MARION COUNTY GROWTH SERVICES

220408Z

Type of Application
Rezoning

From: A-1 (General Agriculture) and B-2 (Community Business)
To: PUD (Planned Unit Development)

Buffers

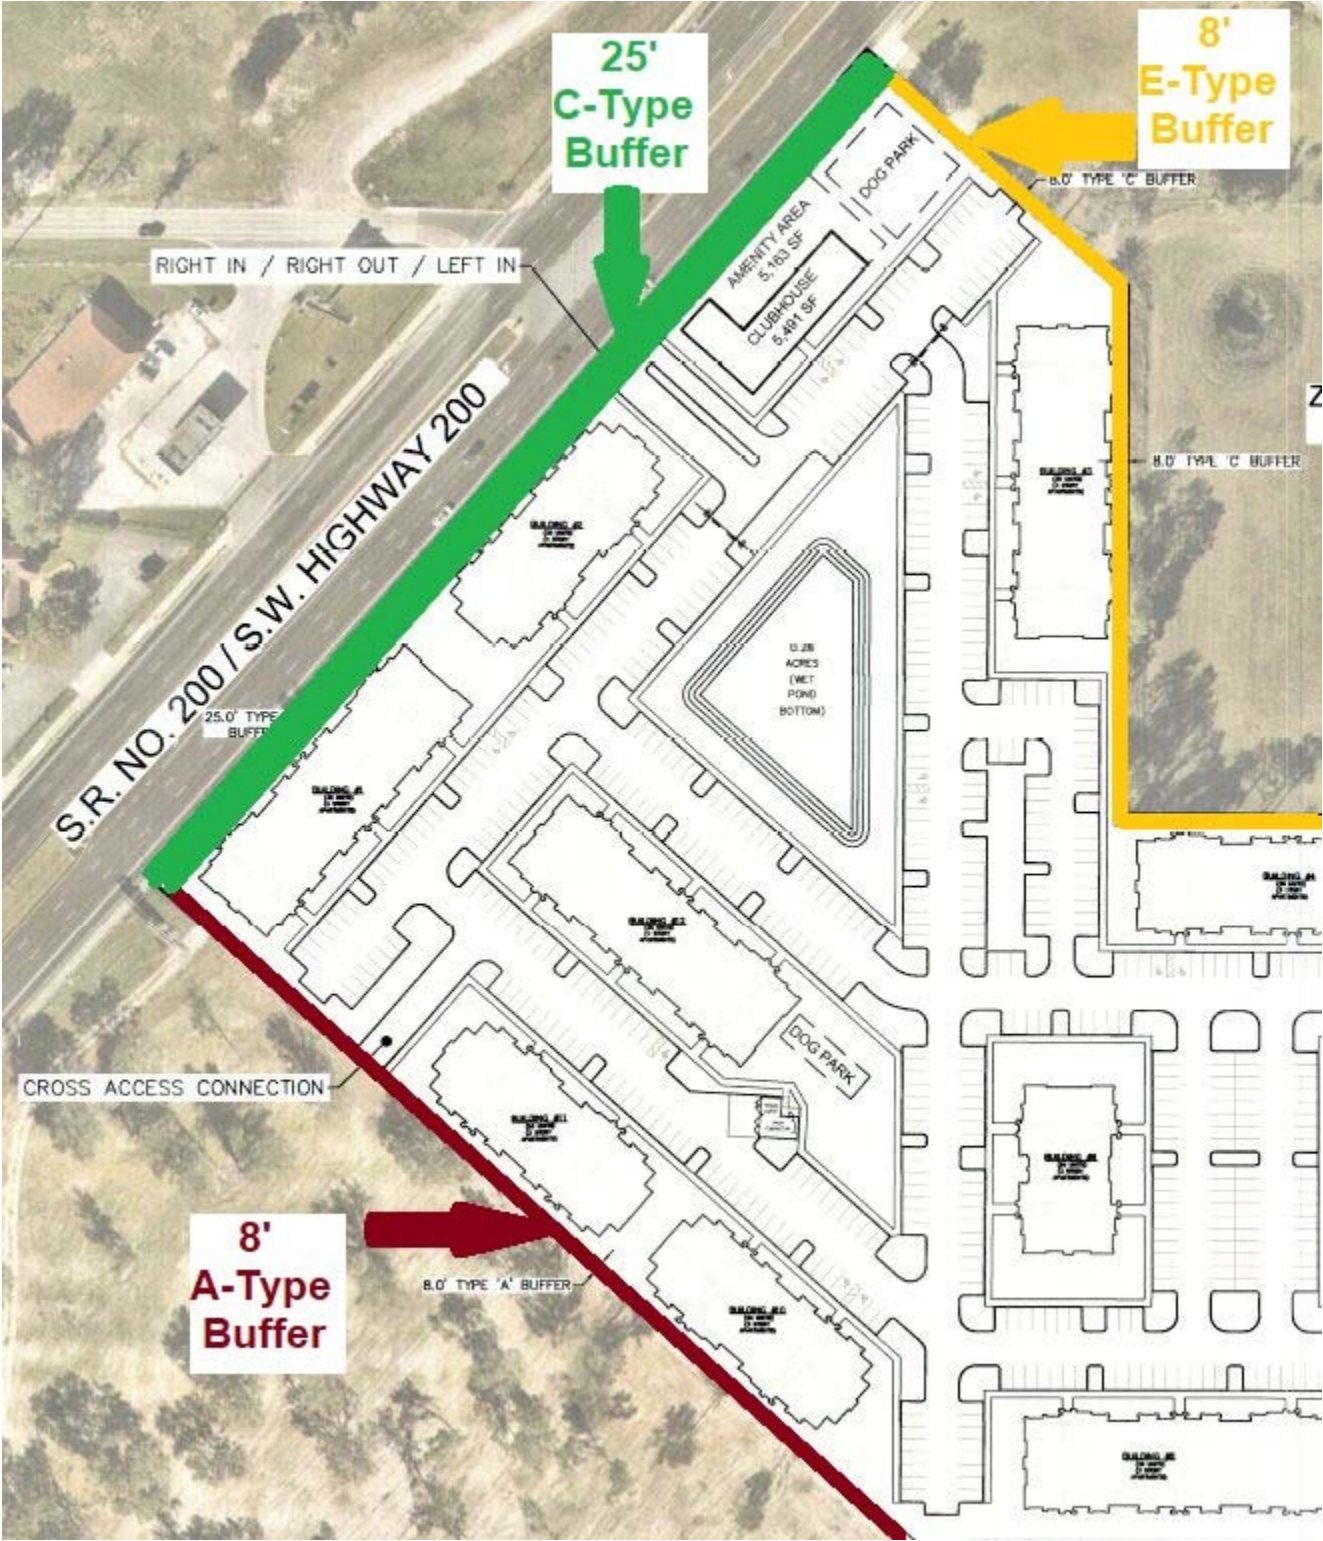
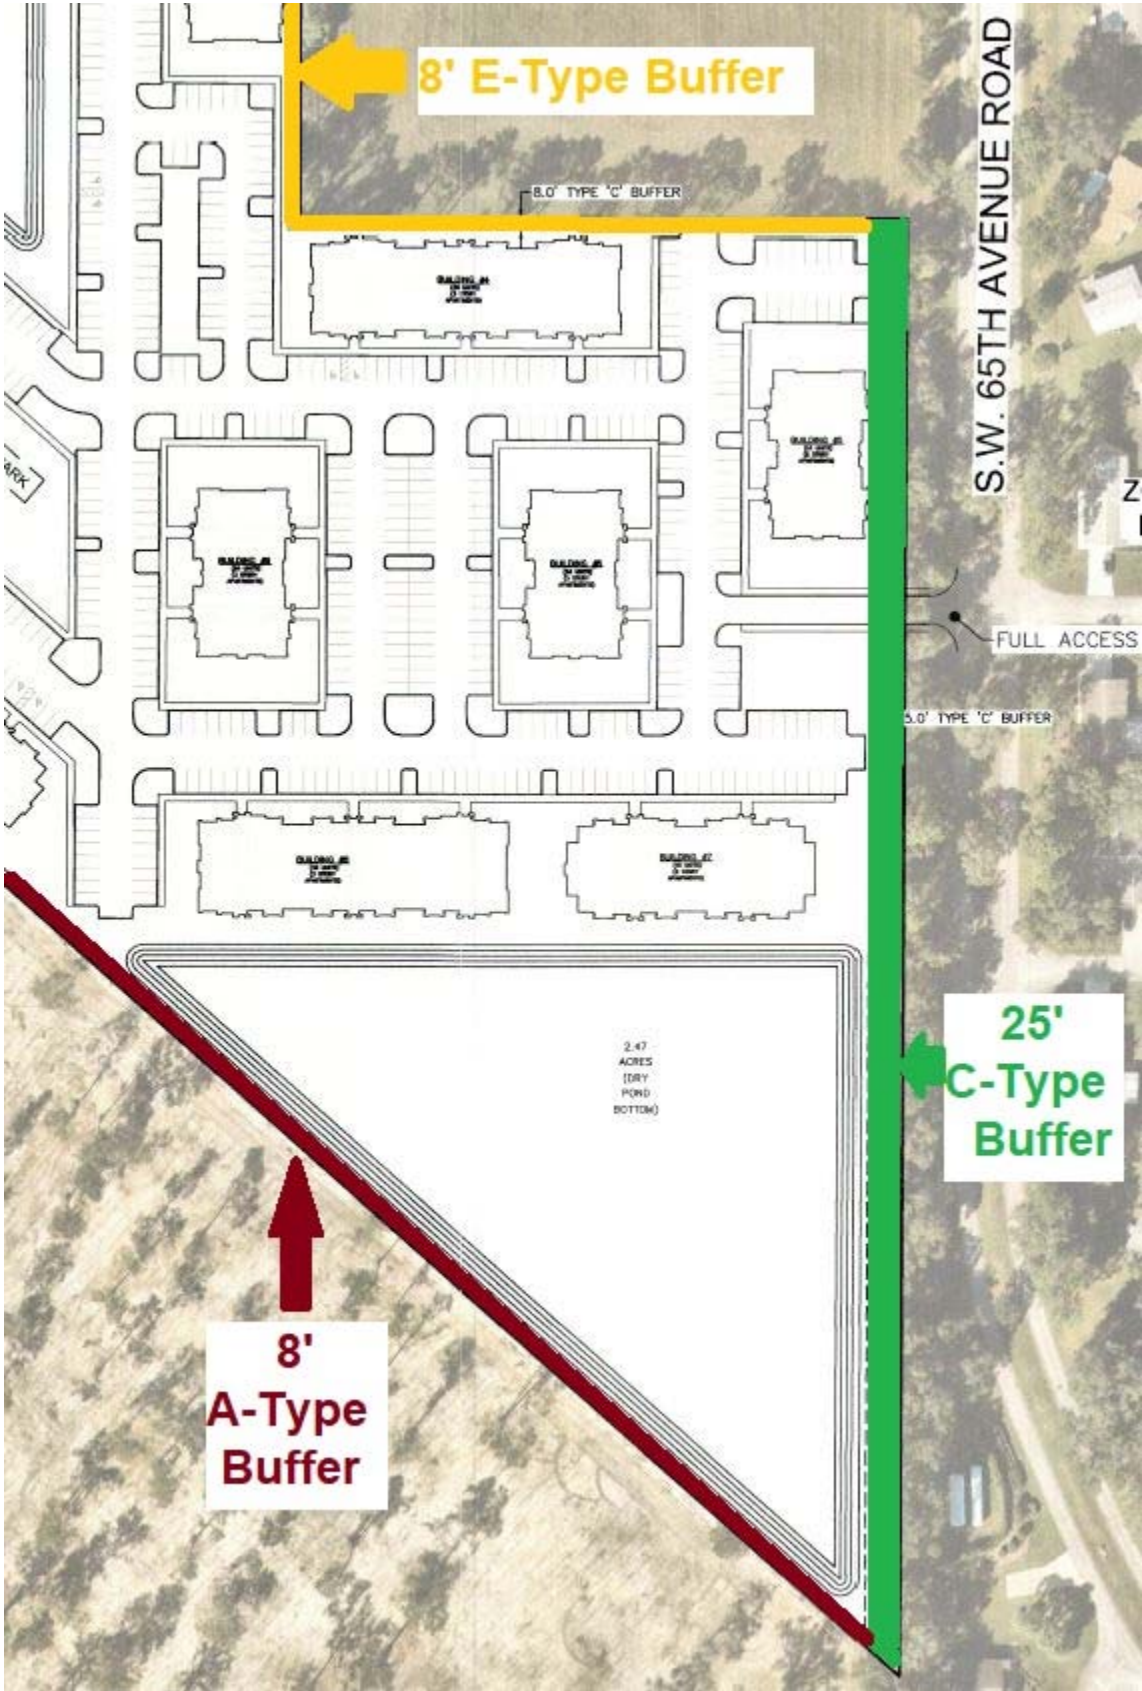
The PUD Conceptual Plan's landscape plan provides for a Type "C" Buffer of varying widths based on a minimum 8-foot wide planting design. Along both Hwy 200 and SW 65th Avenue Road, the overall buffer width is modified to increase the width to 25-feet in lieu of 15-feet as required by the current LDC. Staff supports the increased width as it will accommodate planting the buffer vegetation away from powerlines running along Hwy 200 and away from existing trees in the SW 65th Street Road right-of-way where the new buffer vegetation and existing right-of-way trees will provide a heavier layered buffer screen.

Staff notes that a Type "A" Buffer reference is noted along the southwest boundary shared with the upcoming Laurel Commons PUD; however, the buffer description for the boundary incorrectly references a Type "C" Buffer 8-feet wide. Further, Laurel Commons PUD includes both commercial and multiple-family development wherein a Type "A" Buffer is required along the commercial area, but no buffer is ordinarily required where the project's multiple-family will adjoin the Laurel Commons' multiple-family development. Final determination of the southwest buffer will also depend on the project's final design addressing the need for cross access to the Laurel Commons PUD. The plan also proposes a narrowed 8-foot wide Type "C" Buffer along the site's boundary shared with the FDOT DRA, where ordinarily a 25-foot wide Type "C" Buffer would be required. wherein the buffer would be in a narrow perimeter adjoining the DRA's slopes and the site's proposed buildings. Finally, staff notes the southwest Type "A" Buffer and northwest Type "C" Buffer are an additional concern due to the proposed 8-foot side setback and the limited planting area for proposed for the buffer vegetation. The 8-foot side setback conforms to the LDC for R-3 (Multiple-Family Residential), however, the setback may be insufficient for building and fire code requirements given the proposed 3-story height of the adjoining buildings, as such, increases in those setbacks may be required that may then result in widened buffers. *Staff recommends requiring that the projects' final buffer plans be proposed with the project's final PUD Master Plan, or equivalent, subject to providing the expanded width Type "C" Buffers along the site's boundaries shared with Hwy 200 to the west and SW 65th Avenue Road to the east, with the vegetative plantings along SW Hwy 200 and SW 65th Avenue Road being located along the internal sides of their respective boundaries (e.g., eastern side along Hwy 200 and western side along SW 65th Avenue Road).*
